MEMORANDUM

Subject: CUP 20-0003 – Conditional Use Permit Request for Additional Height in the Downtown

Commercial zoning district for Parcel DC #5 on 1.77 acres in the Midtown Development

VIEW A - FROM CHURCH STREET AND CLAY STREET.

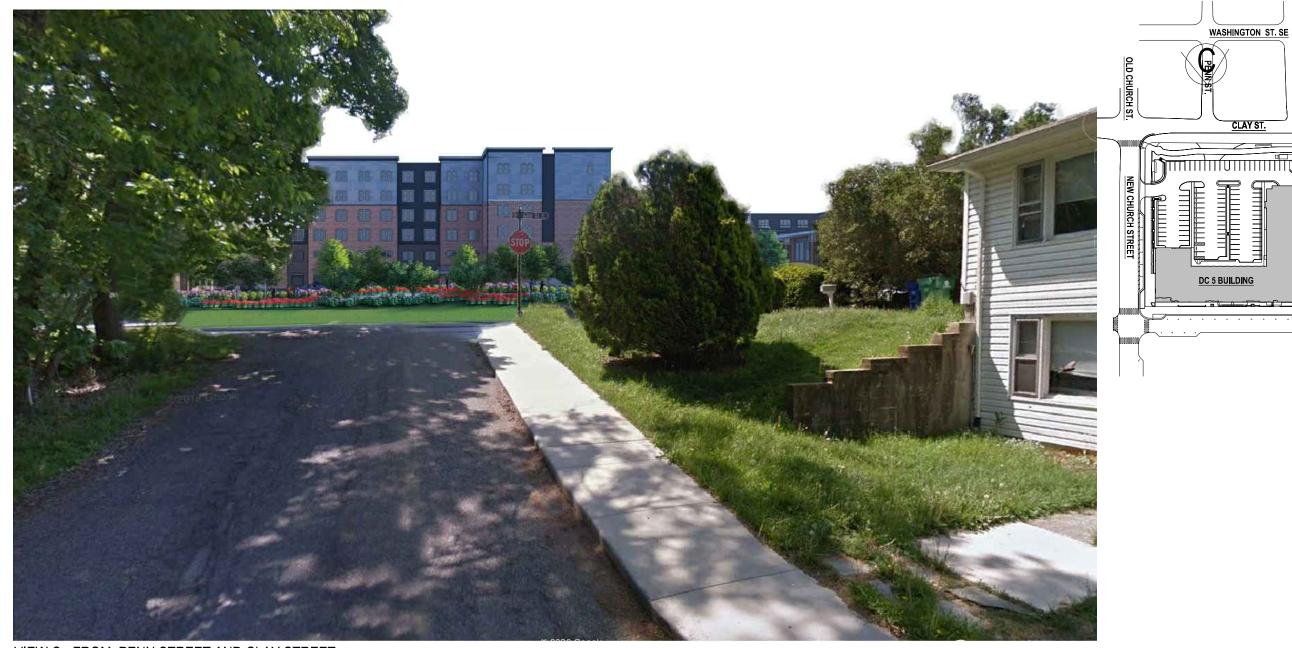
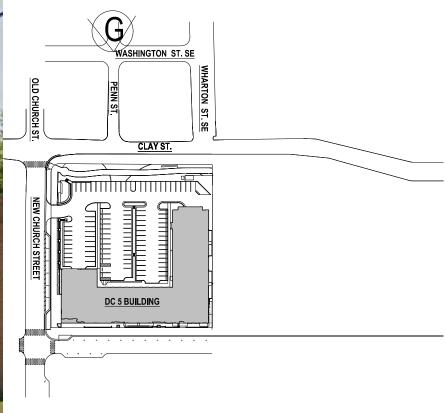
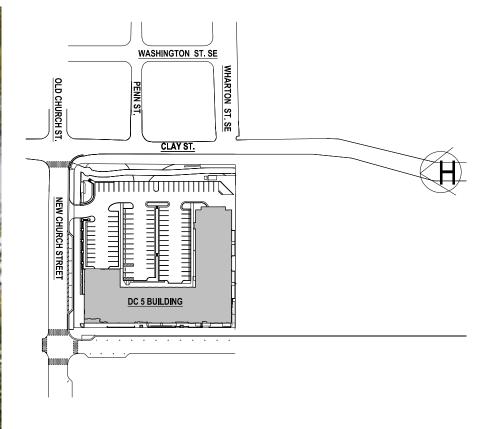
The building height on DC Parcel #5 will have visual impacts on surrounding uses. While the tallest building mass will be experienced at the corner of Midtown Way and Church St. interior to the site, the building will be elevated above Clay St. The building is set back from Clay St. separated by the existing vegetated bank, proposed retaining wall, proposed trail easement, landscaping, and the parking lot. However, the parking lot will sit approximately 15 feet above Clay St. It is estimated that the building will rise some 89 feet above Clay St. The impact on the adjacent uses is slightly exacerbated by the additional height proposed. Building design can help to mitigate the impacts of the building from Clay St. and the adjacent residential areas. Landscaping is proposed in and adjacent to the parking area and will include red maple and linden trees, serviceberry and hawthorn shrubs/small trees and other lower vegetation. Taller evergreen vegetation could help screen the lower portion of the building.

The impact on the development on Parcel DC #5 from Clay St. is important as the proposed development is across from the historic T-intersection of the original 16 squares of Blacksburg at Clay Street and Church Street. The importance of the relationship to the Historic District was noted in the reviews of the initial architectural renderings. The applicant has provided illustrations related to views of the development on Parcel dc #5 from Clay St., which can be found in the CUP application and in Attachment B.

There were concerns expressed in the review of the January architectural submittal that the building design was not sensitive to the adjacent historic district and the suggestion that options for lower building height toward Clay St. might be considered. Building design is challenging with visibility from three street frontages but the most visible frontage to the Town will be the Clay St. side of the building.

(4) CLAY STREET VIEW

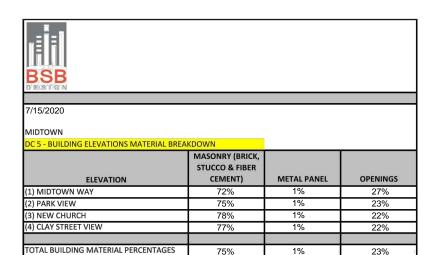
The elevations submitted with the Conditional Use Permit do not show any building step backs. The building articulation is achieved primarily through materials change and balcony elements. The are no changes in the horizontal building plane. There are a variety of building materials proposed including two colors of brick, a gray block patterned fiber cement product, a gray stucco product, three metal colors and perforated mesh. Building elevations and renderings are included in the CUP application and Attachment B.
